July 2021
FL887A
NHTSA #21V-357
Transport Canada #2021-290

Subject: Cascadia Halogen Headlights

Models Affected: Specific model year 2017-2022 Freightliner Cascadia vehicles manufactured March 8, 2016, through May 10, 2021, and equipped with halogen headlights.

Fig. 1, Hood-Mounted Splash Shield Hole Locations

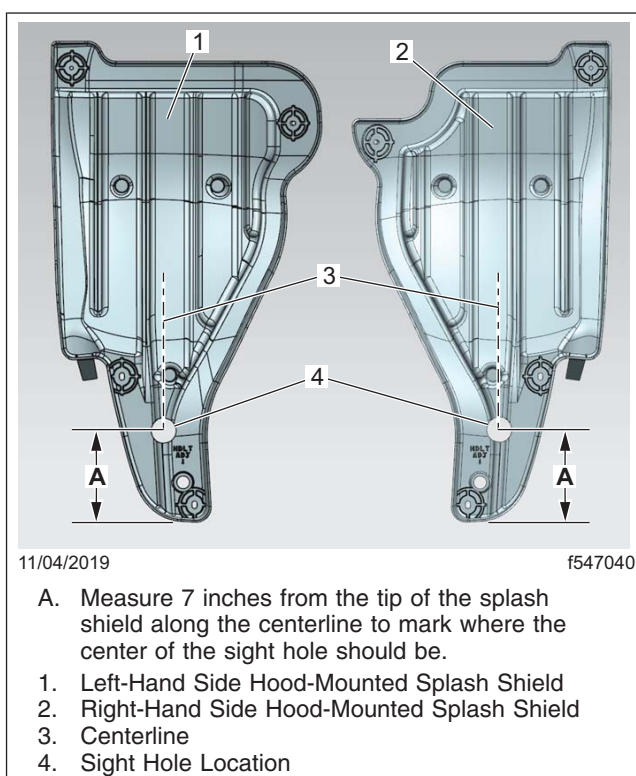
4. Remove the hood mounted splash shields at both sides. For instructions, refer to **Group 88** of the *New Cascadia™ Workshop Manual*.
5. Inspect the splash shields for existing inspection holes. See [Fig. 1](#).

- If no holes exist, go to the next step.
 - If 2-inch diameter holes exist, go to step 7.
 - If 4-inch diameter holes exist, go to step 8.
6. Drill a 4-inch hole in both the hood mounted splash shields as follows.
- 6.1 Measure 7 inches from the tip of the splash shield along the centerline and mark where the center of the sight hole should be. See [Fig. 1](#) and [Fig. 2](#).

Fig. 3, Drilling a 4-Inch Hole in the Splash Shield

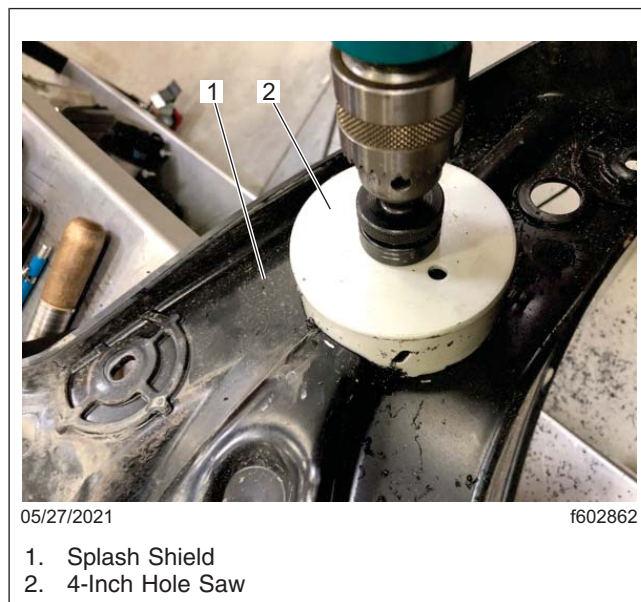
6.2 Using a hole saw, cut a 4-inch (approximately 100 mm) sight hole. See [Fig. 3](#) and [Fig. 4](#).

Fig. 7, Removing the Rubber Grommet

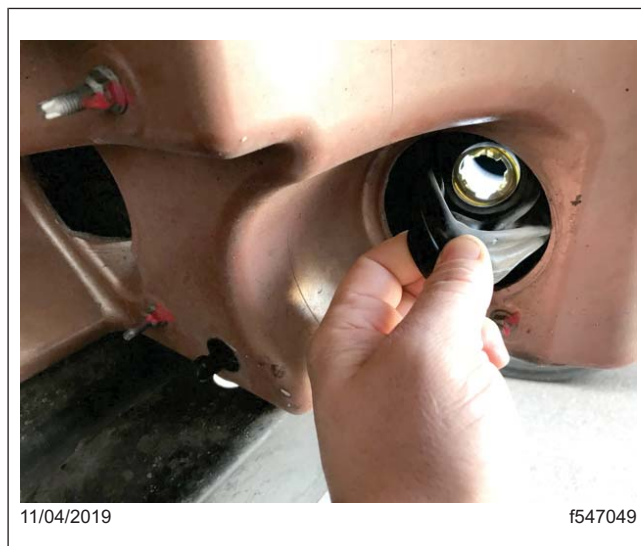
9. Without unplugging the harness, remove the bulbs and set them aside.
10. Inspect the headlamp housing grommet.
- If rubber grommets are present, replace them with foam grommets. Go to next step.
 - If foam grommets are present, go to step 12.
11. Replace the rubber grommets on both the headlamp assemblies with foam grommets as follows.
- 11.1 Remove the rubber grommets and discard them. See [Fig. 7](#) and [Fig. 8](#).

Fig. 9, Installing a Foam Grommet

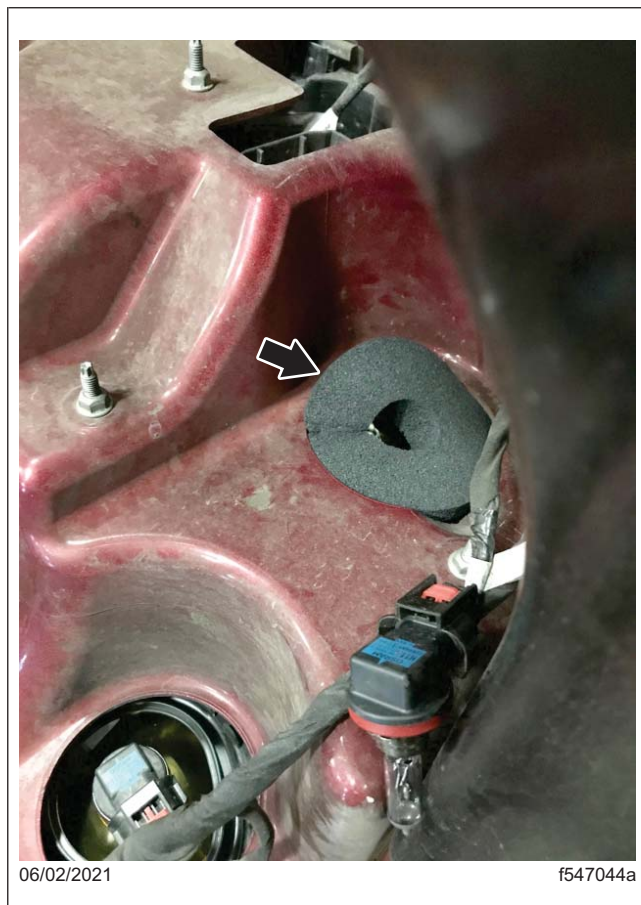
- 11.2 Insert the foam grommets into the headlamp housing. Push and place all the edges inside the housing, and ensure the foam does not interfere with the bulb mounting interface. See [Fig. 9](#) and [Fig. 10](#).

Fig. 11, Headlamp Bulb Installed with a Foam Grommet

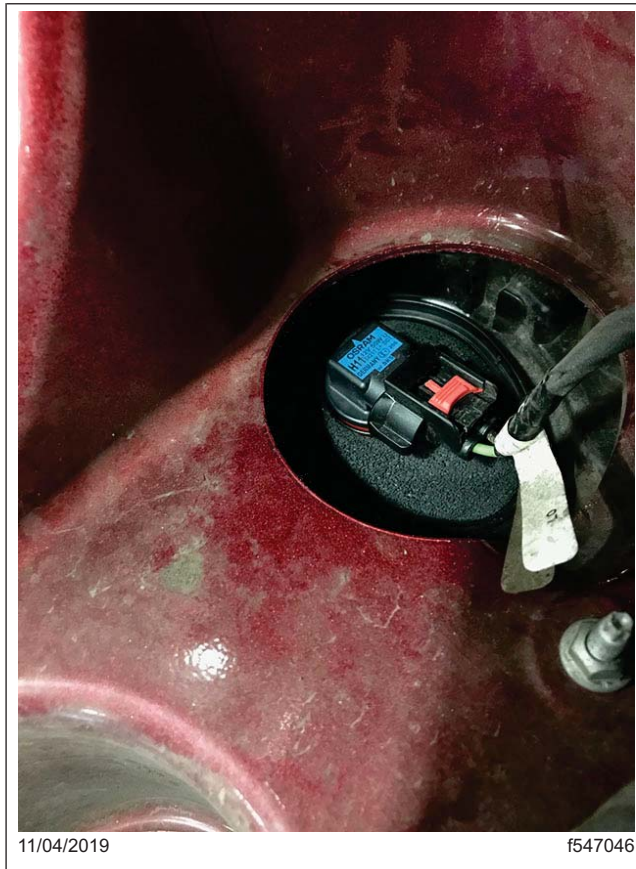
12. Reinstall the four headlamp bulbs. See [Fig. 11](#).
13. Reinstall the four lamp cavity covers onto the hood. See [Fig. 12](#).

Fig. 14, Correctly (LH) and Incorrectly (RH) Seated Headlamp Bulbs

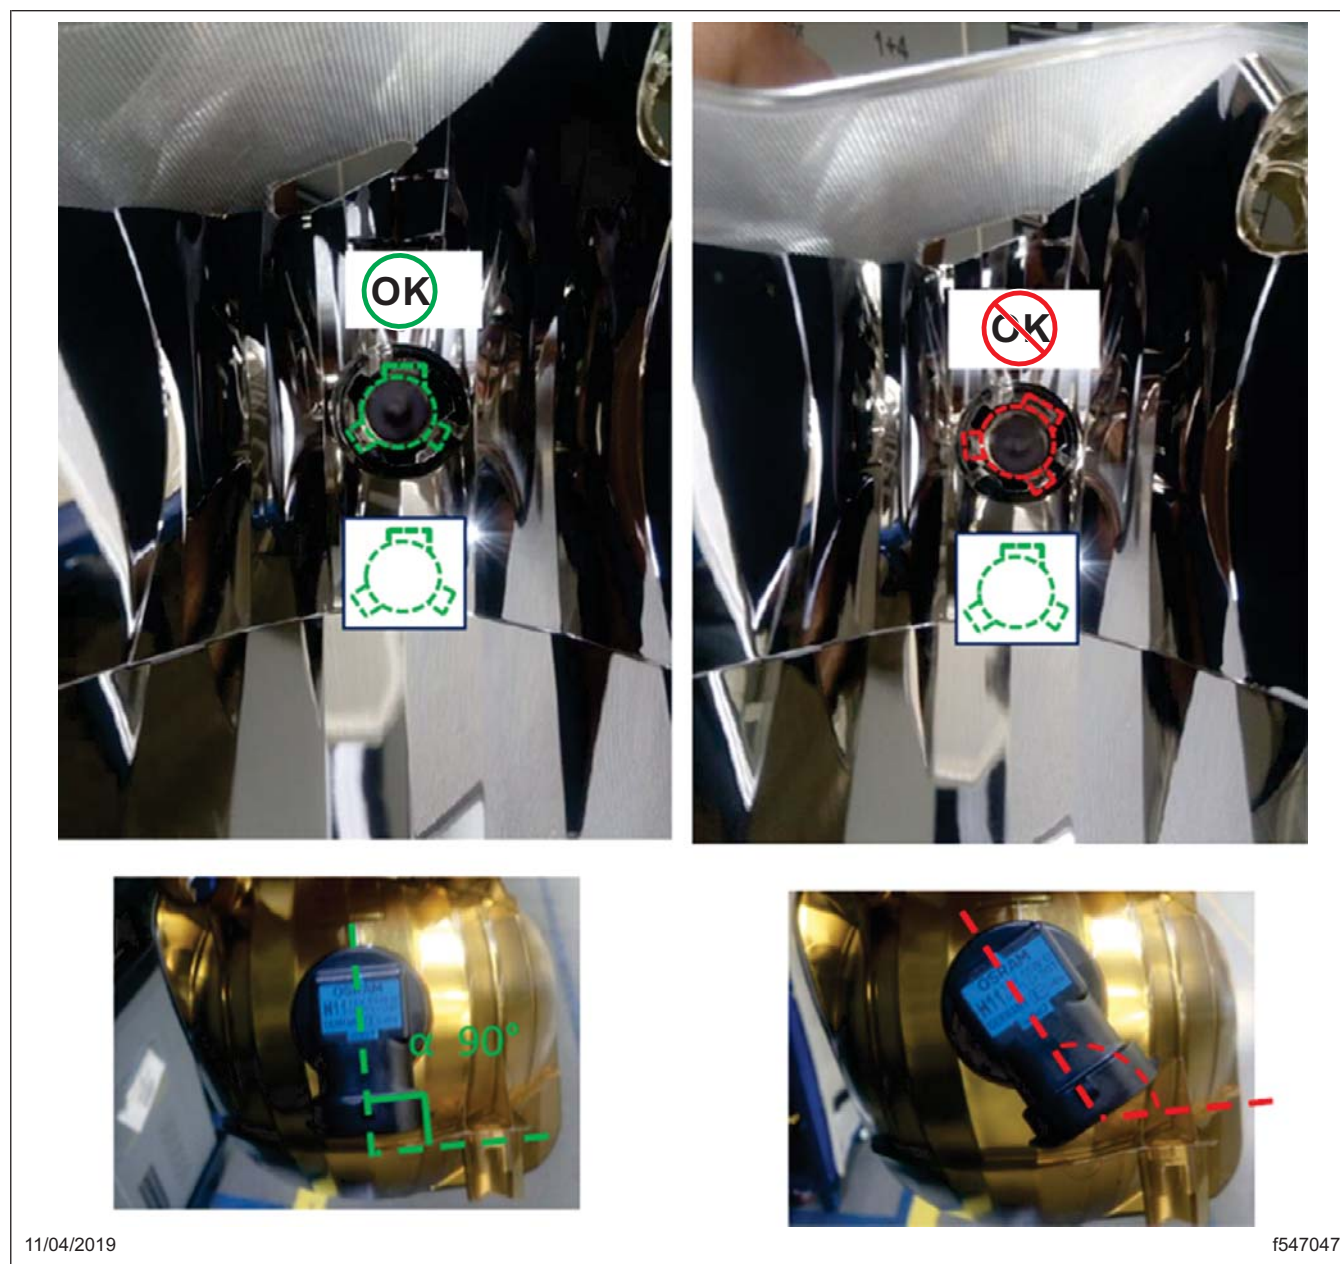
18. Verify all four headlight bulbs are fully seated by looking through the headlamp lens from the front of the vehicle. See [Fig 14](#). If not properly installed, remove and install them properly.
